CITY PLANNING COMMISSION

APPLICATION: A. Negative Declaration

- B. Tentative Map to divide 9.43 partially developed acres into three lots in the General Commercial (Review) (C-2-R) zone
- C. Plan Review of a 1,834 square foot Snappy Lube auto service center on 0.3+ vacant acres in the C-2-R zone.

LOCATION: 7710 Stockton Boulevard

TENTATIVE PARCEL MAP
SNAPPY LUBE

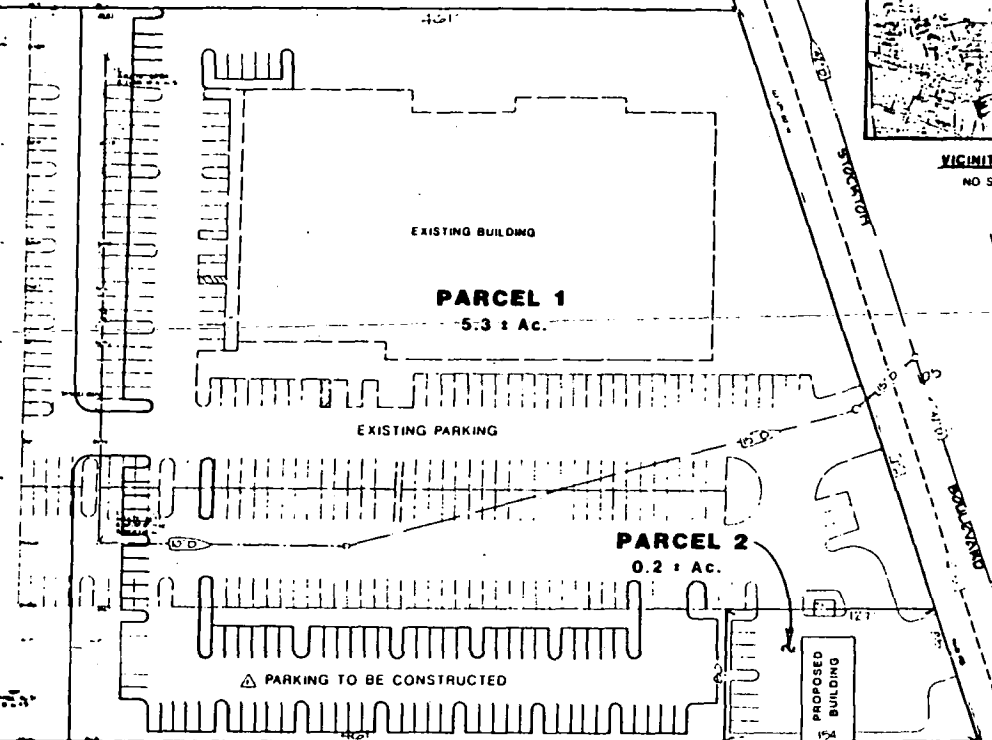
The proposed subdivision establishes a lot without street frontage (Parcel 3). Access will be provided from the northerly extension off Massie Court when it is constructed. Parcel 3 will not be able to be constructed upon until adequate street access and public frontage is provided. A note restricting development until Massie Court is extended to the north will be recorded in the deed to Parcel 3.

The proposed Snappy Lube parcel will require reciprocal ingress and egress easements with Parcel 1. As a note, the Snappy Lube property line may require adjustment so that the trash enclosure is not divided by a property line.

Public Works requests revised map showing realigned right-of-way prior to City Council hearing to the satisfaction of the City Engineer for the proposed I.O.D.

6. Provide an I.O.D. 58 feet wide between Parcels 1, 2 and 3.
7. Provide an I.O.D. 58 feet wide south through APN: 118-131-28 to Massie Court.
8. Coordinate a future alignment through APN: 118-131-034 to the north to the satisfaction of the County of Sacramento.

9. Place the following note on the final map, "No building permits shall be issued for Parcel 3 prior to dedication and construction of standard improvements in 58 foot I.O.D.s."

14. Property lines shall observe buildings and structures. The trash enclosure shall be relocated so to not be divided by a property line.
15. The property on which construction is authorized by this permit may be subject to flooding. It is the applicants and property owners responsibility to ascertain whether and to what extent such flooding may occur, and to review the applicable base flood elevations for the proposed project which are contained in the effective Flood Insurance Rate Map; the Department of the Sacramento District Corps of Engineers, Sacramento, California, Flood Insurance Study for the Sacramento City and County of California, FBFM and FIRM work map, dated January 1989; and, all preliminary flood maps available at the City of Sacramento's Planning Division.

16. A revised parking plan (bowling alley and Snappy Lube) indicating correct number of parking spaces for all uses shall be submitted to the Planning Director for review and approval.

REVISED SITE PLAN

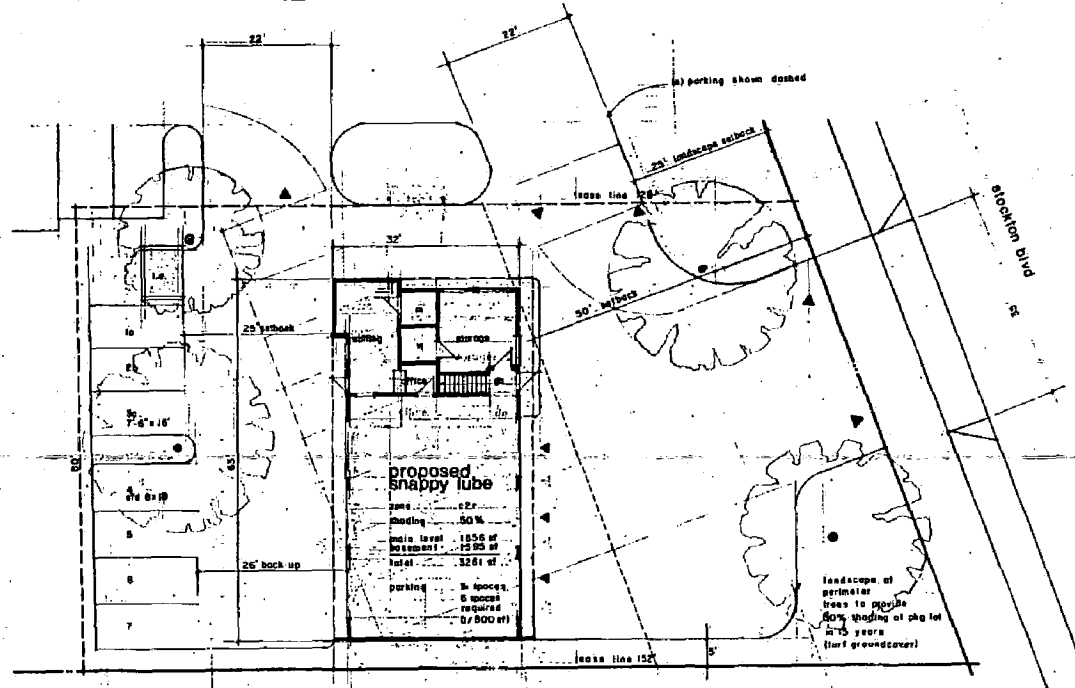
The site plan shows a 1840 square foot, 22 foot high auto service center with eight parking spaces. The site currently provides parking for the bowling alley totaling nine spaces. Required parking for the bowling alley is 288 spaces with six spaces required for each lane. A total of 48 lanes are present. Since the nine spaces being removed are part of the required parking for the bowling alley, nine spaces will be required to be added to the bowling alley parcel. Required parking for each use shall be provided on each parcel. The applicant should be aware that the submitted site plan of the bowling alley does not indicate the correct required number of parking spaces. A revised parking plan must be submitted to staff prior to approval of the final map.

The building will be constructed of wood frame and cement plaster exterior with concrete tile roof and aluminum storefront window systems. Three roll-up doors will be facing Stockton Boulevard. The building is placed on the south property line which requires a masonry block wall. A 50 foot building setback off Stockton Boulevard is required and shown on the site plan. No colors are provided. Staff recommends review of the color scheme by staff and propose use of decorative masonry block on the south building elevation. Staff prefers the building being moved northward five feet to allow a five foot landscape buffer between the south elevation and property line.

Parking and maneuvering areas will be required to comply with the City Tree Shading Ordinance requirements. Reciprocal ingress and egress easements will be required with the lot to the north.

1. Detailed landscaping and irrigation plans shall be reviewed and approved by the Planning Director prior to issuance of building permits. A minimum of 25 foot deep landscape berm shall be planted with turf or grass adjacent to Stockton Boulevard.
2. All parking and maneuvering areas shall comply with the minimum 50 percent shading requirement.
3. The site plan shall be revised to show a five foot building setback from the south property line with a landscape strip adjacent to the building. Tall growing evergreen trees or shrubbery shall be planted adjacent to the south building elevation.

4. Reciprocal ingress and egress easements shall be recorded in the deeds to Parcels 1 and 2.
5. The trash enclosure shall be located so to not be bisected by a property line and be designed to City Trash Enclosure standards.

9. No exterior public address system is allowed.
10. Driveways shall be improved to current City Standards.
11. The parking plan for the bowling alley shall be modified to show nine spaces being added to replace the nine spaces being deleted by the proposed Snappy Lube. A revised parking plan indicating the required parking for all uses on Parcels 1 and 2 shall be submitted to the Planning Director for review and approval.
